## **Exhibit A**

### **Response to Comments Submitted by the Brazos River Authority**

## Attachment A: Mapped Simsboro Transmissivity Values from the Original GAM and the Updated GAM

GMA 22 Update to The Groundwater Availability Model for the  
Central Portion of the Sparta, Queen City, and Carrizo-Wilcox Aquifers

Figure 4 Simsboro Transmissivity Field in the Modified GAM. Line A-A' marks the location between the modified and unmodified Simsboro transmissivity values along in the down dip of the Vista Ridge well field.

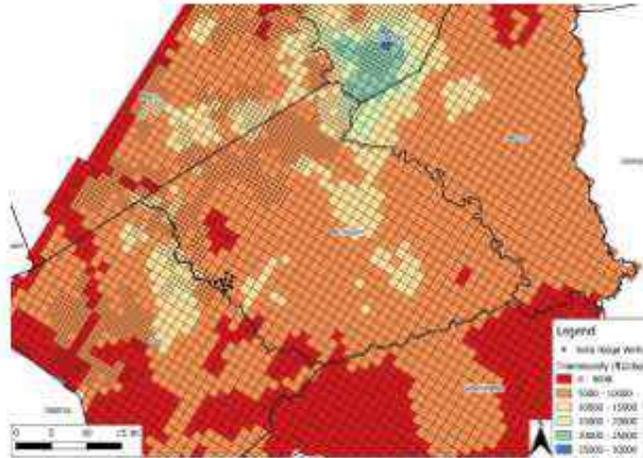
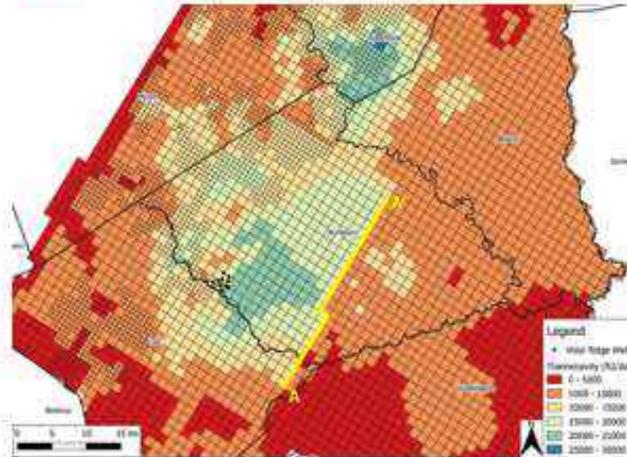
**Comment #2.** There is an apparent box-shaped transition zone between the modified and unmodified cells within the Simsboro Aquifer layer (Layer 9), which is likely a result of the parameter estimations and the methods by which those values were integrated into the original transmissivity field, that should be re-analyzed and possibly corrected.

**Response to Comment #2.** An important point associated the modified transmissivity values is that they were generated by PEST for a very different set of model calibration criteria than used by PEST to generate the unmodified transmissivity values. Thus, the magnitude and spatial variation in the modified transmissivity values should be different than for the unmodified transmissivity values. A second important point is that, along the outermost column or row where the transmissivity values were modified, the average change is less than 25% difference along three out of the four sides. A difference of less than 25% is a relatively small amount given that differences in transmissivity much larger than 25% occur across a mile distance in many regions of the unmodified transmissivity field such as in Robertson County (Attachment A, Figure 3) and among transmissivities that were calculated among the Vista Ridge Simsboro Aquifer screened wells (see Table 1 in the Updated GAM report).

Within the area contained in the box drawn around the pilot points used to modify the Simsboro transmissivity field, the transmissivity values were increased by an average multiplier of 1.7, or 70%, with the smallest and greatest changes in the updip (Northwest) and downdip (Southeast) portions of the box, respectively. Unlike updip portions of the box, where the transition between modified and unmodified transmissivity values are difficult to distinguish, across the downdip portion of the box, the transition between unmodified and modified transmissivity values is easily distinguishable. This boundary is marked by the line A-A' in Figure 4 in Attachment A.

The modified transmissivity values are about twice the values of the unmodified transmissivity value. To explain this increase, we have modified Section 3 of the report to include the following discussion.

“As part of the recalibration of the GAM, several attempts were made to reduce the amount of increase in the Simsboro transmissivity values in the vicinity of line A-A’ shown in Attachment C. These investigations showed that notable reductions in transmissivity values in the vicinity of line A - A’ adversely affected the match between the calculated transmissivity values from the aquifer pumping test and the GAM simulation. Based on these results, we deduced that the Simsboro transmissivity values in the unmodified GAM and in the vicinity of Line A-A’ and down-dip of Line A-A’ were likely a result of a combination of too great of a trend of decrease in hydraulic conductivity with depth that was built into the GAM (Young and others, 2018) and a possible underestimation of net sand thickness down dip of Line A-A’.

We did not pursue additional studies to adjust Simsboro transmissivity values down in the vicinity and downdip of Line A-A’ for several reasons. One reason is that the additional studies is beyond the scope of GMA 12’s directive to modify the GAM by adjusting the hydraulic conductivity values of the Simsboro Aquifer in the vicinity of the Vista Ridge well field. Another reason is that the pursuit of additional studies would likely prevent the completion of the modified GAM for use by GMA 12 for the current planning cycle. In addition, the GMA 12 consultants are unsure if there is sufficient hydrogeological data to properly guide the changes in the Simsboro transmissivity field down dip of Line A-A’ at this time.”
